## PRODUCT CHANGE NOTICE

**PCN23-055**

**PMA3-14LN+**

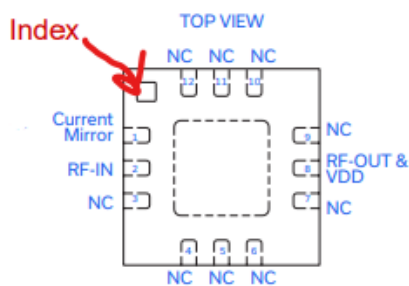
Change to datasheet and PL drawing to identify INDEX metallization as INTERNAL GROUND

Function	Pad Number	Description (See Figure 1)
Current Mirror	1	Current Mirror Pad. Feedback to RF-IN via L1. See details in Figure 1.
RF-IN	2	RF Input Pad.
RF-OUT & VDD	8	RF Output Pad & DC Pad.
NC	10	No Connection, Even Soldered on Test Board.
NC	3-7,9,11 & 12	No Connection, Grounded on Test Board
GND	<del>Paddle</del>	Ground *

**Paddle, Index**

\* Paddle & Index internally connected

No change to FIT (Dimensions), FORM (Appearance), FUNCTION (Performance)  
 No change to the device. PCN issued to alert customers to INDEX status as INTERNAL GROUND
